Subject: Liberty's Response to Notice of Violation – NOV_LU_CAC17_20231116

Finding: Failure to replace expulsion fuses with non-expulsion fuse alternatives / Failure to remove tree attachment(s).

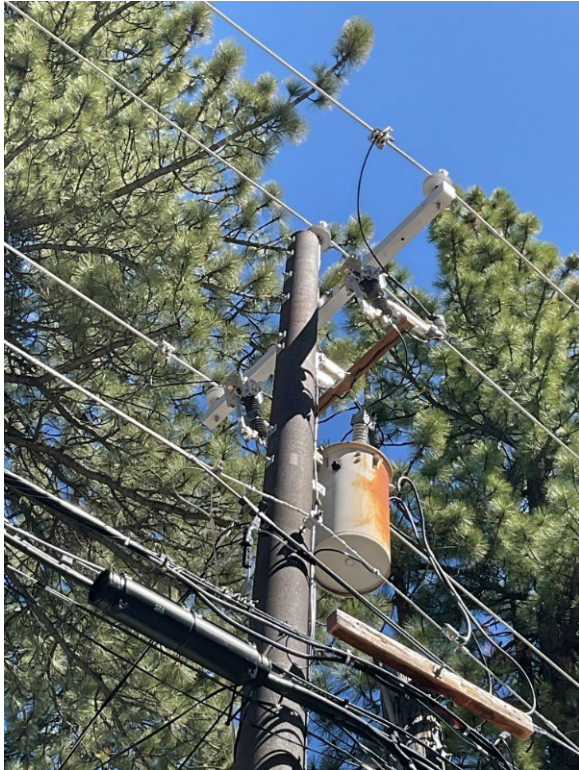
Violation 1. Energy Safety observed that in implementing 2022 WMP initiative 7.3.3.7 – Expulsion Fuse Replacement, Liberty Utilities failed to complete the replacement of expulsion fuses with non-expulsion fuse alternatives on pole ID 292087 at coordinates 39.2426041412934, -120.048456796215. Energy Safety considers this violation for failure of completeness to be in the Minor risk category.

Liberty Response 1 - Liberty disagrees with Energy Safety's observation that it failed to complete the replacement of expulsion fuses with non-expulsion fuse alternatives on pole ID 292087 because Liberty did not report that work as completed in its Quarter 3 2023 spatial data report. Additionally, at the time of this response, Liberty has replaced the expulsion fuse on pole ID 292087 with a non-expulsion fuse alternative to reduce wildfire risk. The following photos show the completed work at this location:

Map depicting location of removed tree and tree attachment:

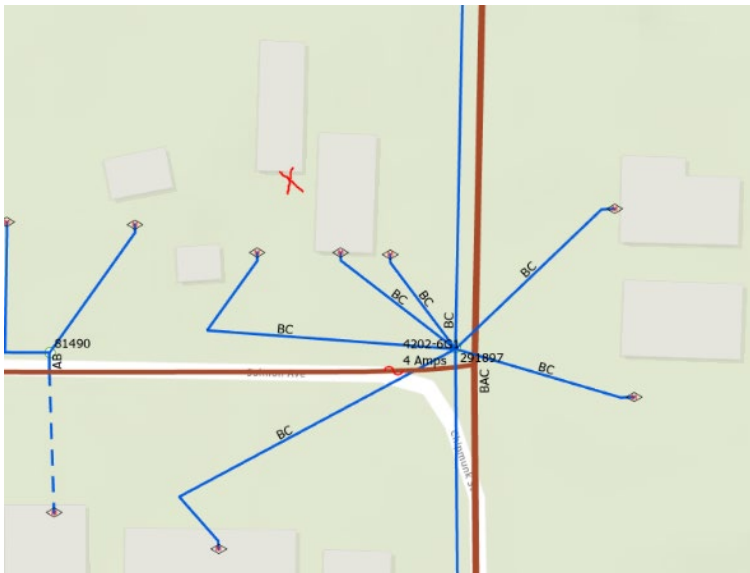
Violation 3. Energy Safety observed that in implementing 2022 WMP initiative 7.3.3.12 - Tree Attachment Removal, Liberty Utilities failed to complete a tree attachment removal on pole ID 291897 at coordinates 39.2361242144599, -120.016292223114. Energy Safety considers this violation for failure of completeness to be in the Minor risk category.

Liberty Response 3 - Liberty disagrees with Energy Safety's observation that it failed to complete the removal of a tree attachment on pole ID 291897 because Liberty did complete that tree attachment removal as reported in its Quarter 3 2023 spatial data report. It is possible that Energy Safety's observation was of other tree attachments in the vicinity. The following photos identify the completed work at the pole ID 291897 location:
